Access Compliance Report

Public Rights-of-Way

(Curb Ramps)

Intersection ID: 14509	Main Street: CARONIA_ST	Cross Street: HIRAM_ST	Location: SW
ADA ID: 0FFDE15F96E7	Ramp Type: PerpDiag	Initial Pass/Fail: Fail	Overall Compliance: No
		Severity Score: 50

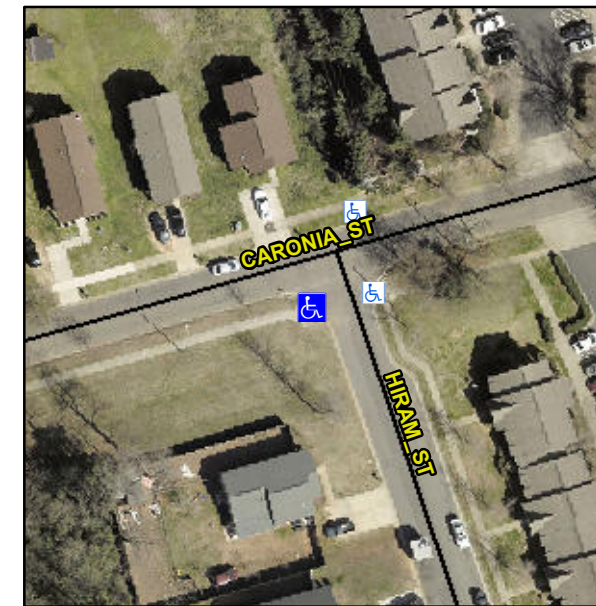
R304.2.2, R304.5.3

Compliance	Description	Data	Compliance	Description	Data
N/A	Ramp Length (in)	143.0	No	Ramp Slope (%)	13.3
Yes	Ramp Width (in)	48.0	No	Ramp XSlope (%)	8.9
N/A	Flare Type LT	N/A	N/A	Flare Type RT	N/A
N/A	Flare Slope LT (%)	N/A	N/A	Flare Slope RT (%)	N/A
N/A	Flare Traversable LT?	N/A	N/A	Flare Traversable RT?	N/A
N/A	Landing Length (in)	N/A	N/A	DWS Provided?	N/A
N/A	Landing Width (in)	N/A	N/A	DWS Contrast?	N/A
N/A	Landing Slope (%)	N/A	N/A	DWS Length (in)	N/A
N/A	Landing X Slope (%)	N/A	N/A	DWS Full Width?	N/A
N/A	Landing Curb? (Y/N)	N/A	N/A	DWS Offset (in)	N/A
N/A	Shared Landing?	N/A			
N/A	Gutter Ponding?	N/A	N/A	Gutter Slope (%)	N/A
N/A	Gutter Lip Ht (in)	N/A	N/A	Gutter X Slope (%)	N/A
N/A	Painted X Walk1?	No	N/A	Painted X Walk2?	No
	X Walk 1 Direction	To E		X Walk 2 Direction	To N
N/A	X Walk 1 Width (in)	N/A	N/A	X Walk 2 Width (in)	N/A
	X Walk 1 Slope (%)	5.4		X Walk 2 Slope (%)	4.8
	X Walk 1 X Slope (%)	4.2		X Walk 2 X Slope (%)	7.1

Remove & Replace Curb Ramp With Two New Directional Ramps or Equivalent.
